Determination 2018/009

Regarding the refusal to issue a code compliance certificate in respect of remedial work to the decks to Units 220, 221, 224, 225, 228, 229, 232, and 233 at Terrace Downs Villas, Lake Coleridge Road, Darfield

Figure 1: As-built plan of a typical deck (plan for units 220, 224, 226, & 232 mirrored, not to scale)

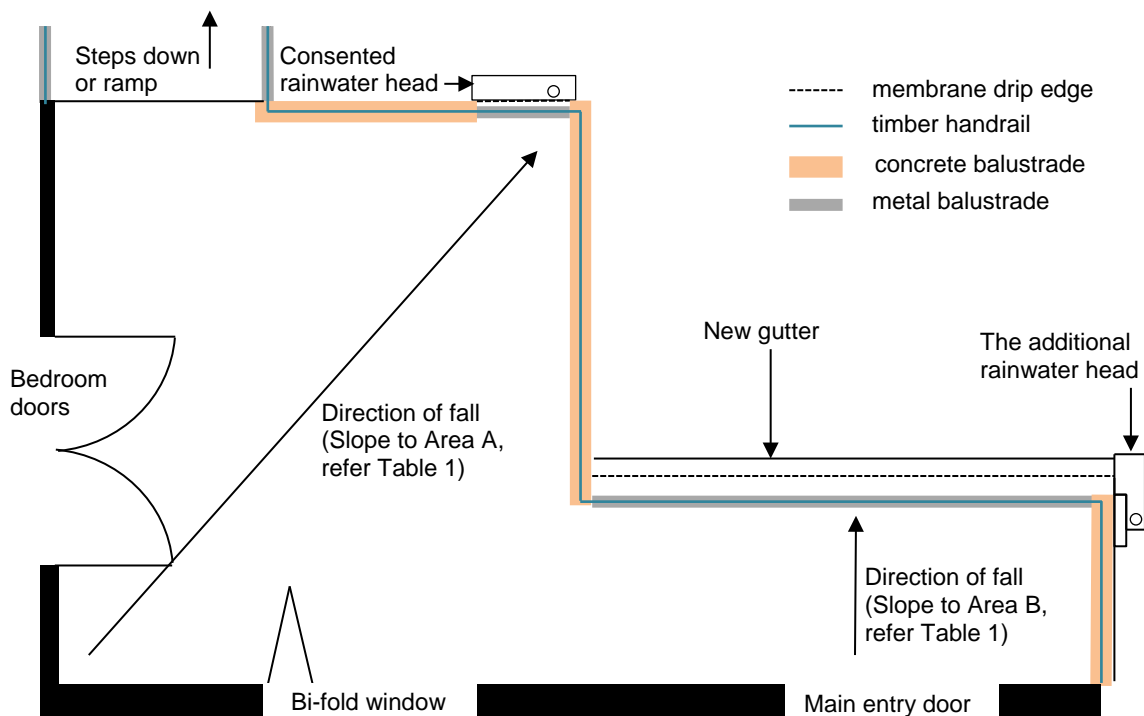
5.4.1 The expert measured the decks' cross falls to areas A and B noted in Figure 1 as follows:

Unit	Area A	Area B
220	0.5°	2.3°
221	0.4°	1.8°
224	0.6°	1.7°
225	0.5°	1.1°
226	0.8°	1.9°
229	0.7°	1.4°
232	0.7°	1.9°
233	0.6°	2.0°

- 6.4.3 Based upon the expert's measurements, in seven of the eight decks one area (Area B in Figure 2) exceeded the 1.14° slope stated in D1/AS1. However, Acceptable Solutions provide only one means of establishing compliance. Some Acceptable Solutions cover the worst case scenario, so they may be modified in less extreme cases and the resulting alternative solution will still comply with the Building Code.

- 6.4.4 In this case, I am of the view the deck slope satisfies Clause D1.3.3(c) for the following reasons:
- The maximum cross-falls exceeding the 1.14° limit range from 1.4° - 2.3°. At most, this exceeds the 1.14° limit by 0.26° - 1.16°.

- The membrane surface has adequate coefficient of friction to be used on slopes up to 9°.
- The area of deck with the slope exceeding 1.14° is narrow, and there is a full-length barrier and handrail along the “down slope” side of the deck at this point.
- The expert’s observation of the greatest slope, at 2.3°, did not feel unsafe to walk along. The slope in the direction of travel did not feel unsafe.

Figure 2: Balustrade height at locations shown (plan for units 220, 224, 226, and 232 mirrored, not to scale)

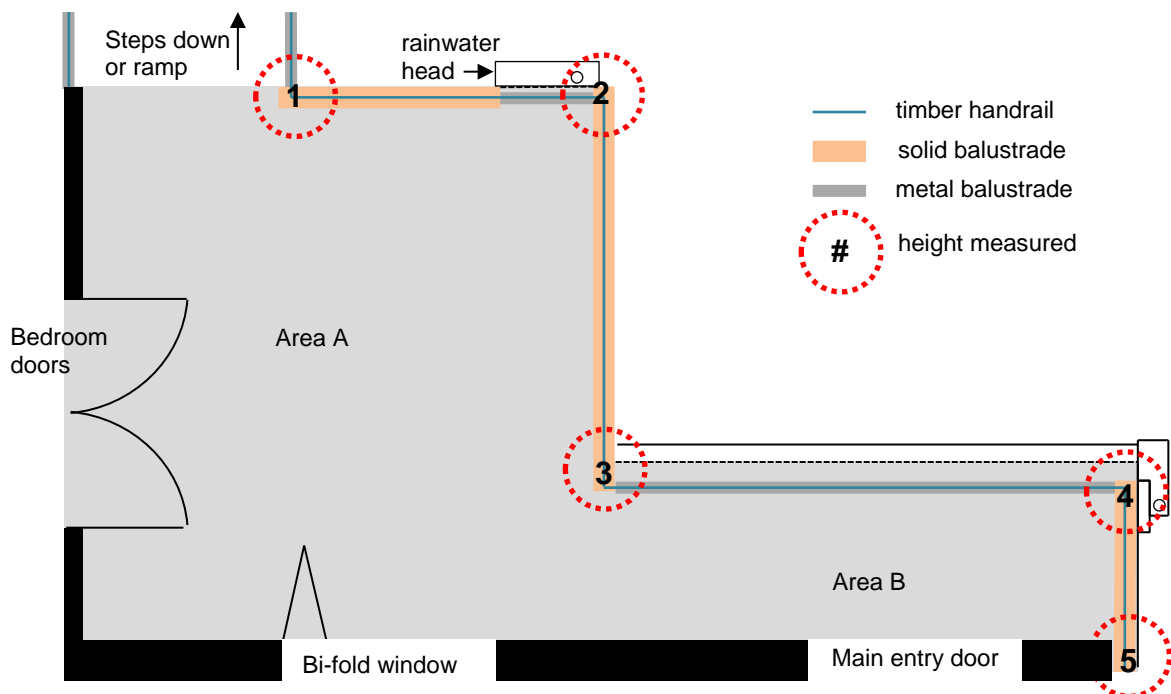
5.5.1 The expert measured the height of all the balustrades in response to the authority's assertion that one unit's balustrade was not appropriately high to comply with Clause F4. He measured the balustrade heights at the locations shown in Figure 2 with results shown in Table 2.

Unit	Location				
	1	2	3	4	5
220	990	1000	990	1000	950
221	1000	1000	980	990	950
224	990	1000	1000	990	960
225	1000	1000	1000	1000	980
226	980	1000	990	1000	980
229	1000	1000	1000	1000	1000
232	990	1000	990	1000	950
233	980	1000	1000	1000	990

6.5.3 The expert measured the barrier heights to the decks and, in places, found a shortfall of between 10-50mm below the 1000mm minimum barrier height stated in Acceptable Solution to Clause F4, F4/AS1, most notably at the higher points in the deck screed. A 40-50mm shortfall was measured in respect of a very short section of barrier next to the entry door to four of the eight units.

6.5.5 I accept the expert’s opinion that it is very likely that the shortfall in height existed before the remedial work commenced.

- 6.5.14 As a result, section 112(1)(b)(ii) applies in this situation, as the barriers, both in respect of the shortfall to some barrier heights and the gap under the balustrade to Unit 228, “did not comply with the other provisions of the Building Code immediately before the building work began, [and will] continue to comply at least to the same extent as it did then comply”. The compliance of the deck barriers is no worse than it was immediately before the work began.
- 6.5.15 I consider the barriers comply with Clause F4 to the extent required under section 112.
